2009~2014 YZF-R1 (“R1”) and 2012~2013 XTZ1200 (“Super Ténéré”)

FACTORY MODIFICATION CAMPAIGN – Headlight Terminal Overheating

Heat damage to the headlight terminal coupler as a result of thermal expansion of the terminal connector.

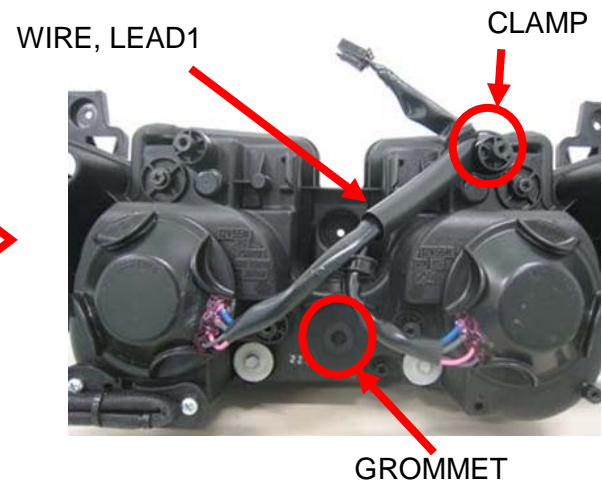
Yamaha Motor Corporation, U.S.A. has decided that a defect which relates to motor vehicle safety exists in 2009~2014 YZF-R1 and 2012~2013 XTZ1200 (“Super Ténéré”) model motorcycles. In affected motorcycles, due to improper heat resistance of the headlight bulb terminal connector, thermal expansion of the terminal connector can cause arcing between the terminal connector and the headlight bulb contact, resulting in coupler melting. If this happens, the headlight might malfunction which could result in the possibility of a crash with injury or death.

To correct this problem, Yamaha is initiating a Factory Modification Campaign. Affected units must have the headlight bulb sub-lead replaced.
